**Re.: Clonburris SDZ – Mixed Use Development – Clonburris T2**

**Register Reference: SDZ22A/0018**

**Response to Request for Additional Information - Landscape**

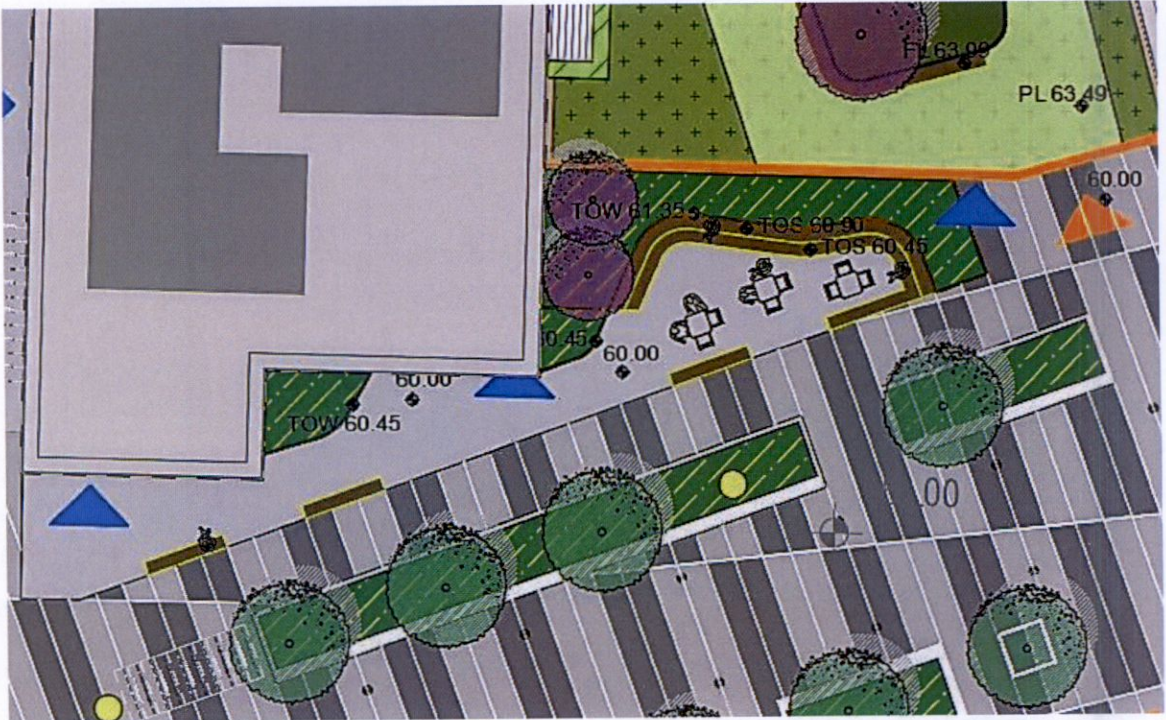
**d. There are concerns regarding the street between Blocks A and B, where there are few ground floor units and a significant level of plant / cycle storage etc. There are also concerns regarding the level of active uses along the pedestrianised street. The applicant is requested to consider more active uses (including the provision of more apartments) along this street.**

- As part of the strategy for activating the space between Blocks A and B, a café garden terrace is proposed to activate the space. This terrace is heavily planted with biodiverse and textured pollinator planting species which will enhance the streetscape, and furnished with bespoke furniture including a feature bench and mobile tables. The terrace space with feature paving and space for several outdoor tables, which can spill out from the corner café unit. As this space is south-facing it will have a pleasant aspect and add positively to the animation and atmosphere of the street. This space is intended to be a focus in the emerging community,

- Other changes to the building frontages have been made in the architecture and building usages to result in additional activation of the south side of the street with a bike hub and additional retail. The landscape has been adapted to ensure that people can freely access the building entrances and retail windows.
- Please see Drawing no. 1868\_PL\_P\_01, reference images and sketch below and associated drawings which indicate revisions to the landscape design including the café garden terrace.

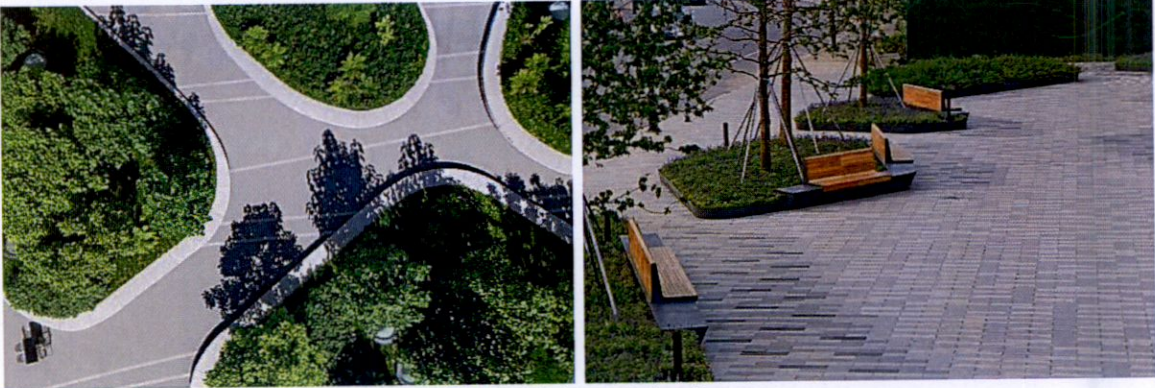
***b. Landmark Buildings should be designed in a manner that is distinctive from surrounding buildings both in terms of architectural treatment and use of materials. To further emphasise their place-making function, Landmark Buildings shall incorporate high quality public realm treatment in terms of surrounding street planting, furniture, lighting and materials etc.***

***The design of such buildings shall therefore be based on a coherent design concept that is clearly communicated via a Design Statement and Landscape Plan. In addition to the above and the requirement of Section 2.8.2, Design Statements for Landmark Buildings shall also analyse and illustrate the impact of the proposed development in relation to its immediate and wider context including views/vistas within and beyond the SDZ lands and in terms of sunlight and daylight effects.***

- Landscape design proposals around the landmark building have been substantially revised to create an area with unique character and identity as a setting for the Landmark Building.

- The ground pattern picks up on the oblique geometry of the eastern elevation of the building and 'fans' out from there, creating a distinctive plane of contrasting materials, which will be selected to be unique in the urban core area.

- A series of island and edge planters with curved, informal forms will create relief within the hard landscape areas, and will be planted with textured, diverse planting.

- Fire access has also been considered and the route has been revised to allow for greater planting and detail around the landmark building.
- Shared surface paths around the building will allow for continuous and convenient cycle and pedestrian access through the space.

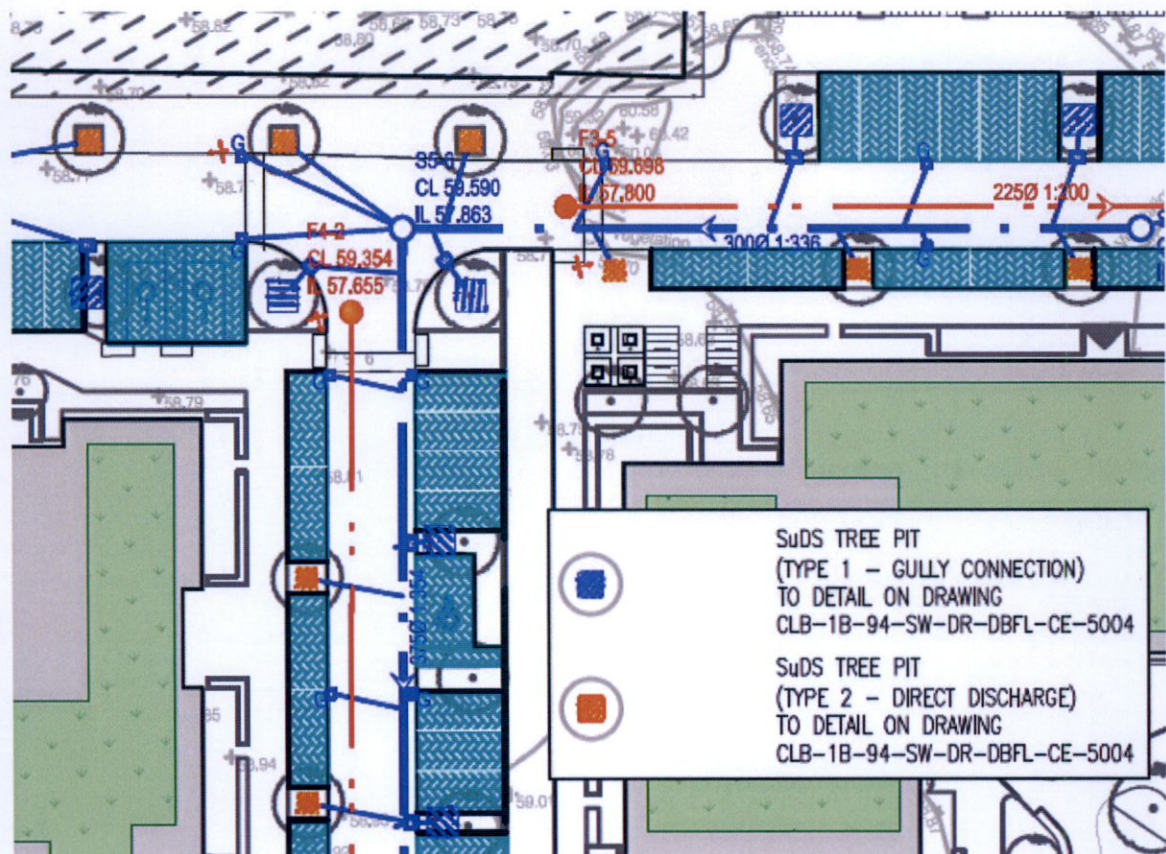
- b. *the applicant is requested to set out measures to strengthen Strategic and Local Green Infrastructure connections within the site and to clearly identify links to adjacent existing / approved corridors.*

Additional trees and planted areas have been incorporated into the design of the Strategic and Local Green Infrastructure connections on the northern and eastern boundaries, as described above and also along the north-south roads where possible.
